LAKE PONTCHARTRAIN, L.A.  
AND VICINITY  
**LAKE PONTCHARTRAIN  
HIGH LEVEL PLAN**

**DESIGN MEMORANDUM NO. 20  
GENERAL DESIGN**

**ORLEANS PARISH  
JEFFERSON PARISH  
17th. St. Outfall Canal  
(Metairie Relief)**

CELMV-ED-PG (CELMN-ED-SP/15 May 90) (1105-2-10c) 3d End  
Mr. Eckenrod/ts/5925  
SUBJECT: Lake Pontchartrain, Louisiana and Vicinity, High Level Plan, Design  
Memorandum No. 20 - General Design, 17th Street Outfall Canal

ENCL 2<sub>2</sub>

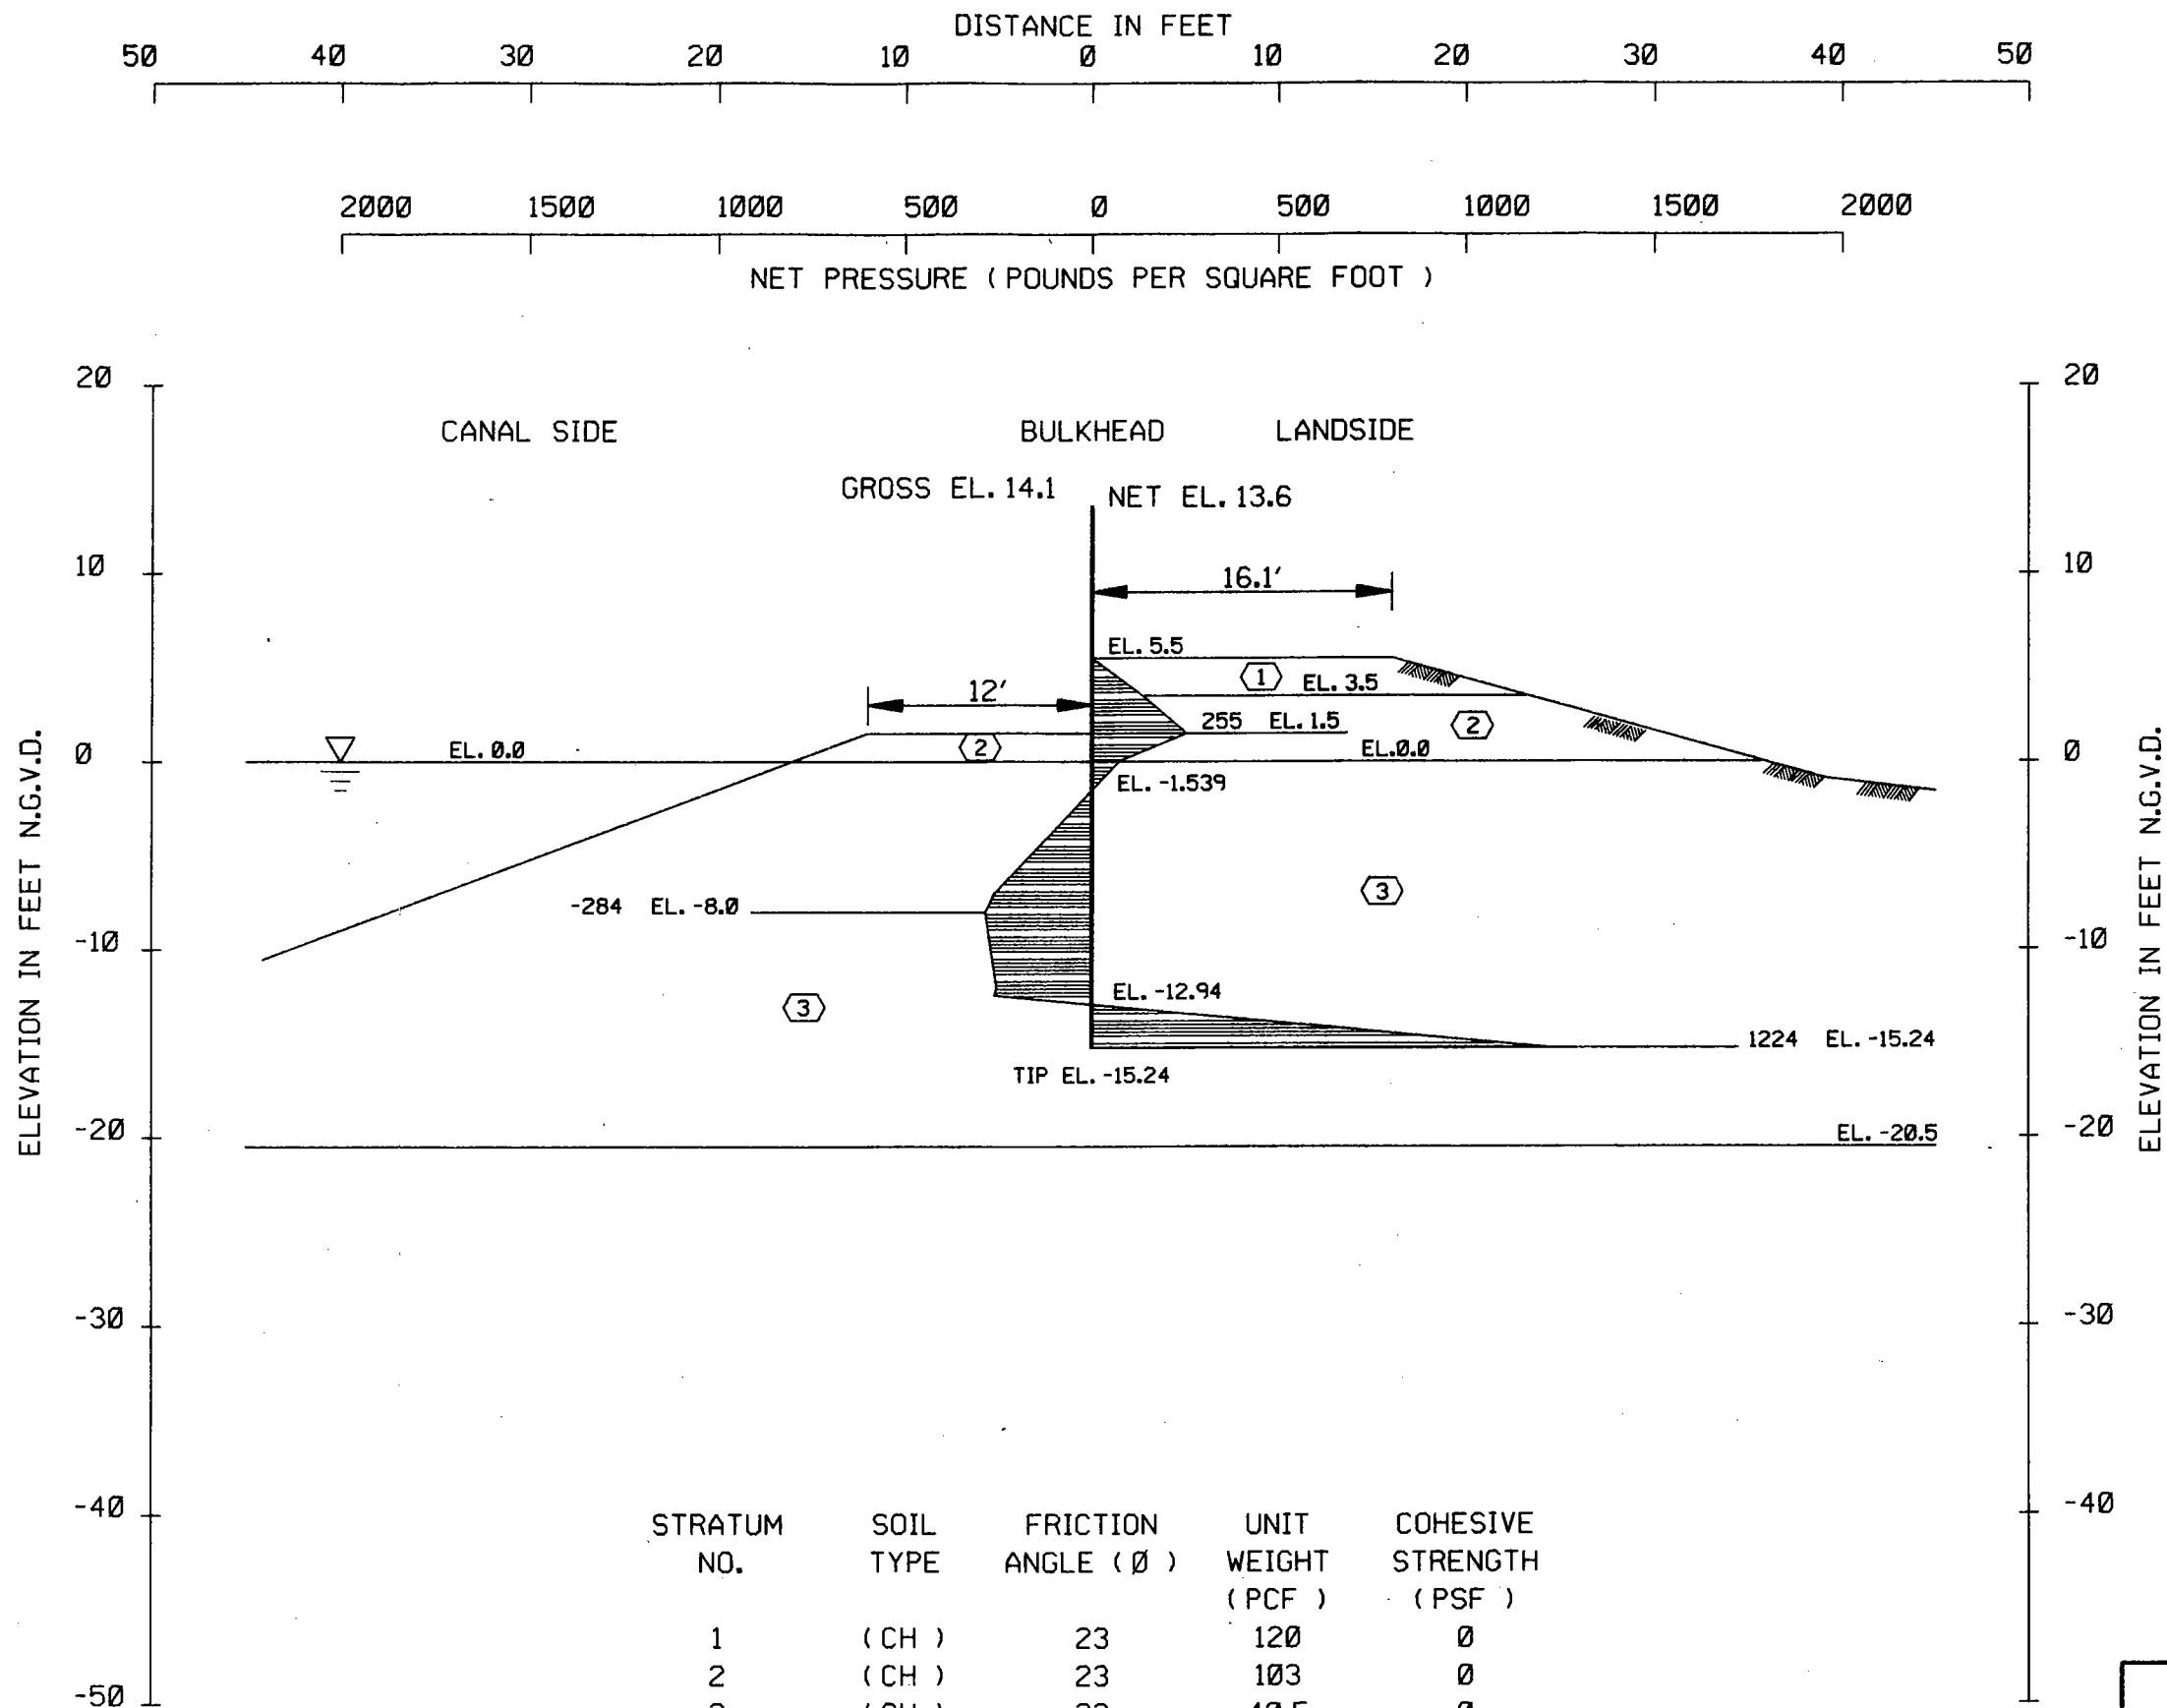
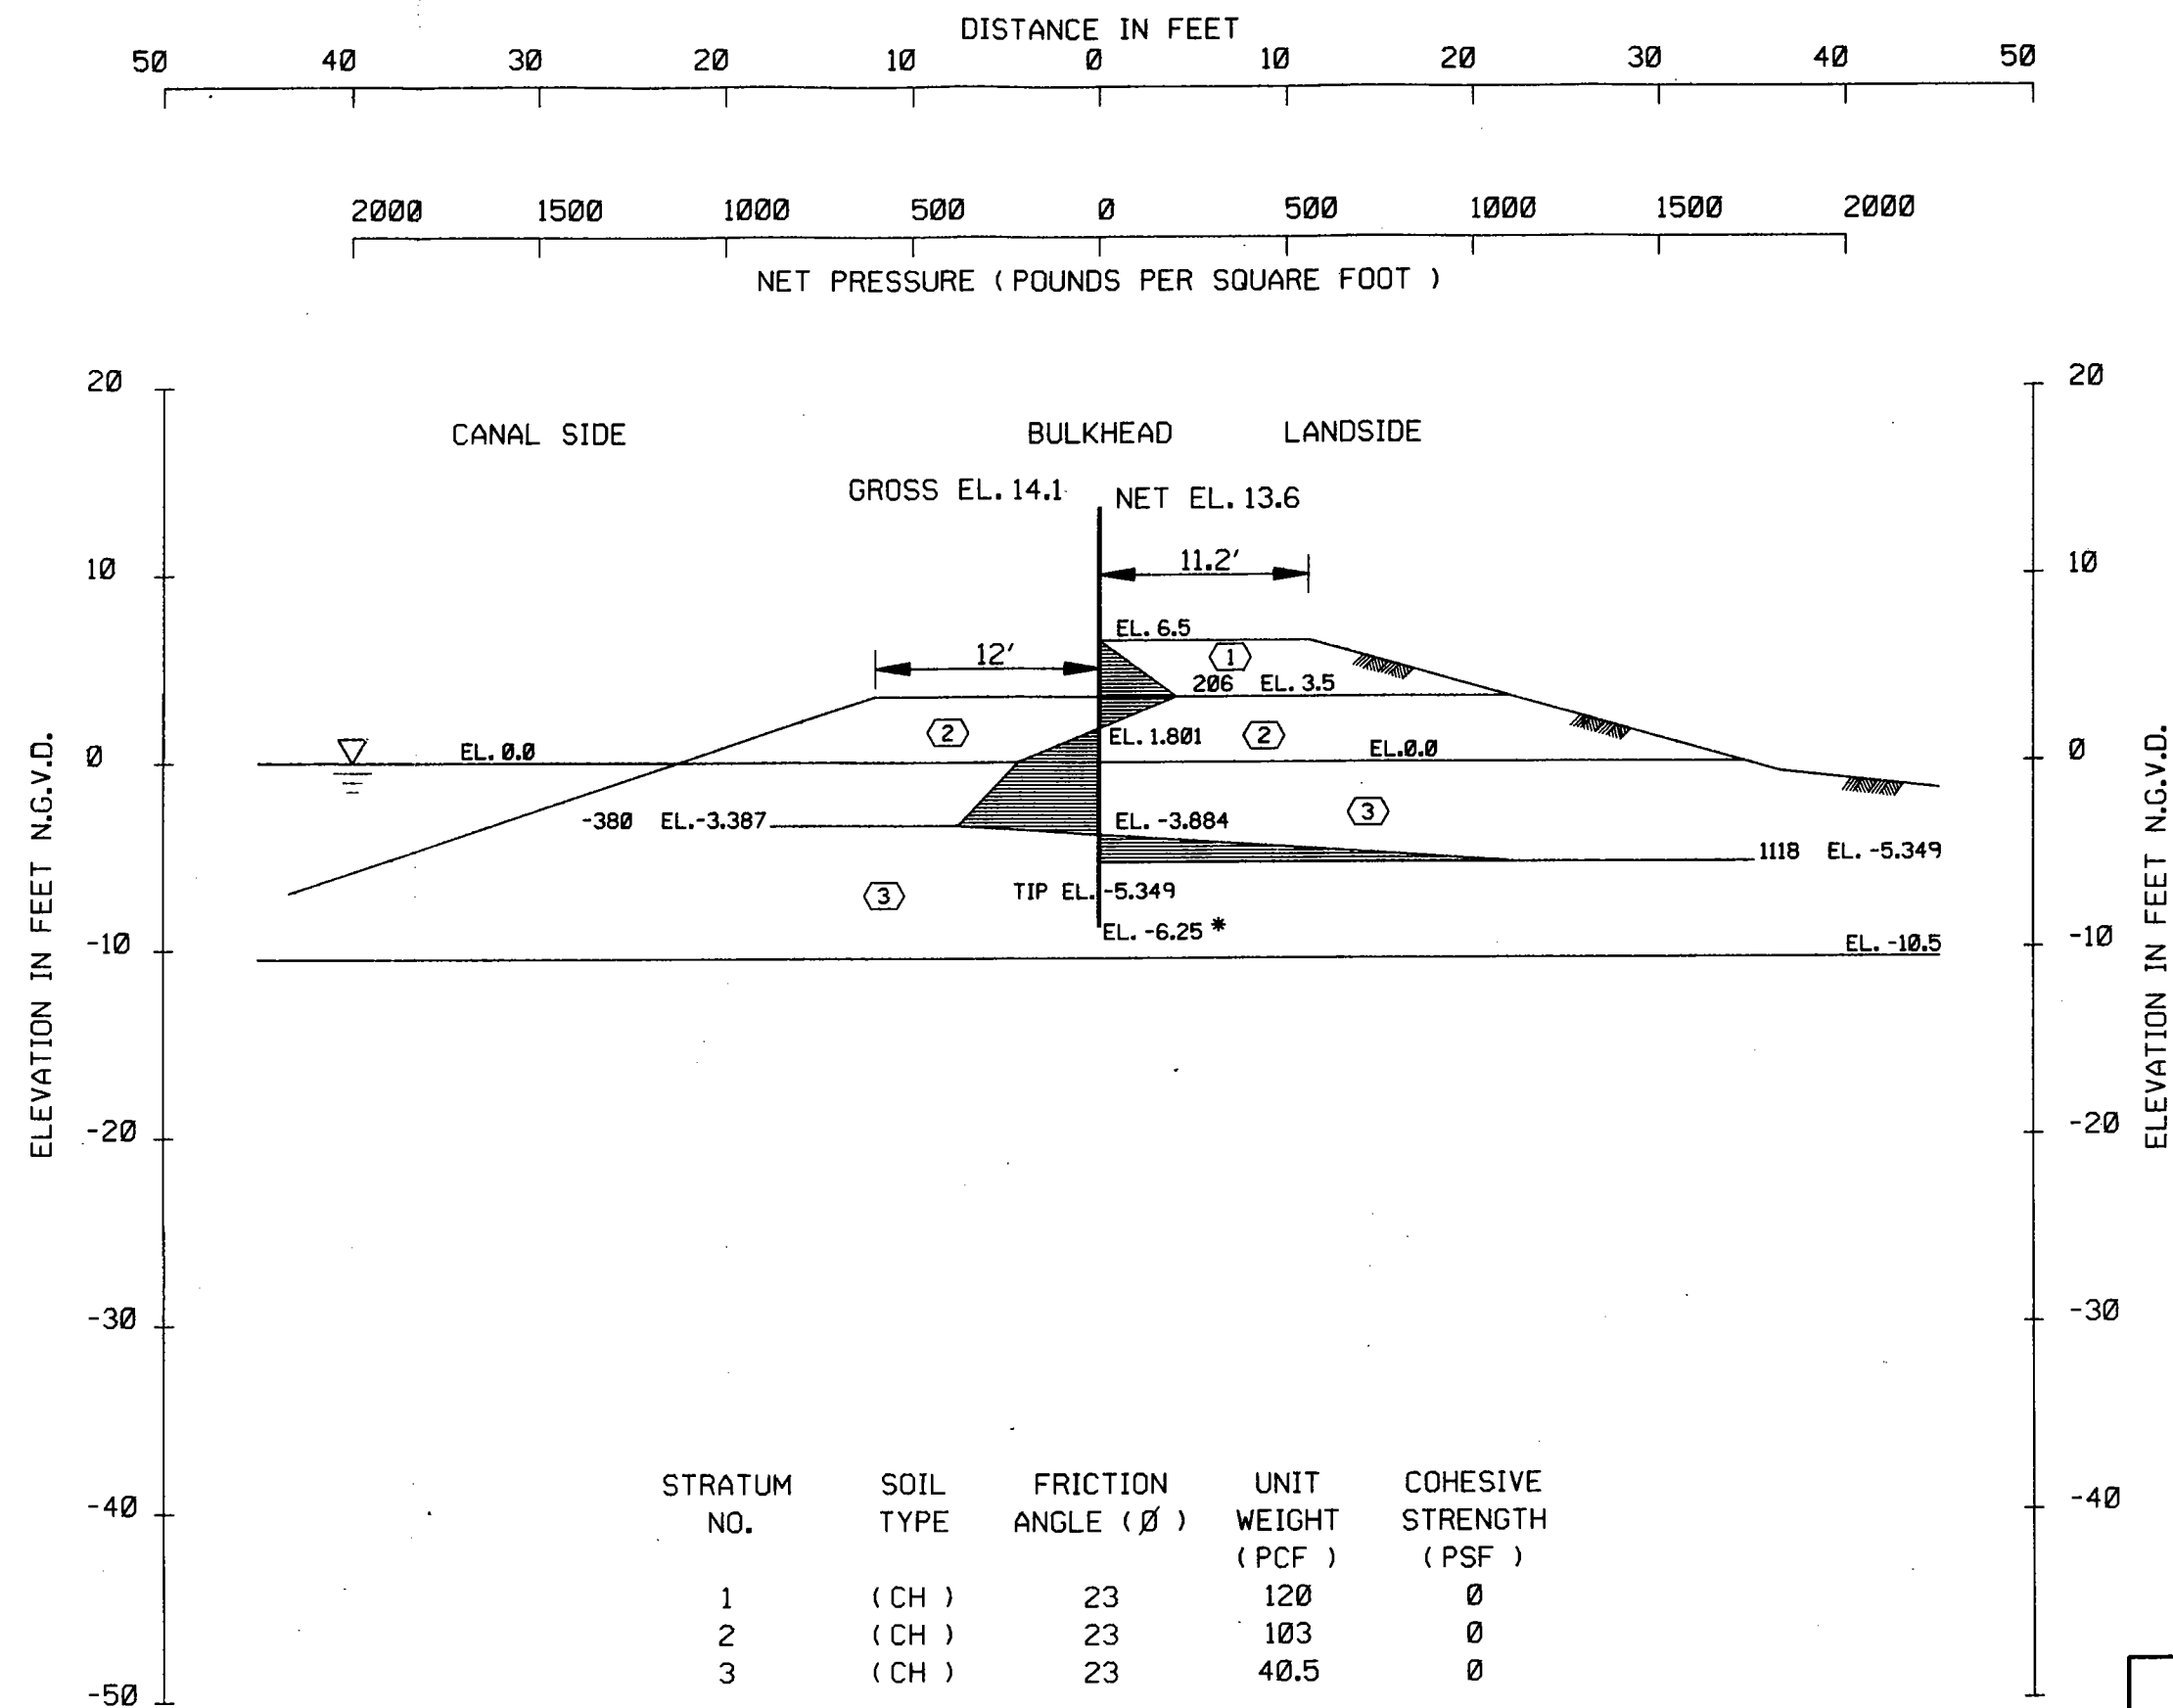
d. Para 29c. Also refer to the tied back and braced wall analyses on Plates 121-124. These analyses are based on the "Q" case soil strengths, a canal level at el -5.0, and a factor of safety of 1.5. Since these sheet pile bulkheads permanently retain soil, they should also be analyzed using "S" soil strengths, a factor of safety of 1.5, and at the normal canal level of el 0.0.

m. Plates 121 through 124. The walls shown on these plates should be evaluated for the anchor forces and resulting stresses on the anchors and the sheet piling should be checked using the conditions shown except change the water level on the canal side to el 0.0 NGVD and use soil properties for the 'S' case and a F.S. = 1.5.

d. Comment d. Para. 29c. The analyses presented were for the Q-CASE soil strengths, a canal level at EL. -5.0 and a factor of safety of 1.5. For plates 121, 122, and 124 the actual design (completed before Dec 87) was controlled by the S-CASE, F.S. = 1.5, and canal level at EL -5.0. The design on plate 123 (completed after Dec 87) was based on the S-CASE F.S. = 1.2 with canal level at EL -5.0; S-CASE F.S. = 1.5 with canal level at EL 0.0; or the 3:1 penetration to head ratio. All the braced walls and tieback walls have been constructed. The tip penetrations shown on plates 122-124 are deeper than the minimum required tip penetration (Encl 3). Intermediate tip penetrations were used to reduce the anchor forces.

m. Comment m. Plates 121 through 124. Concur. Revised plates 121 through 124 are enclosed as Encl 3.
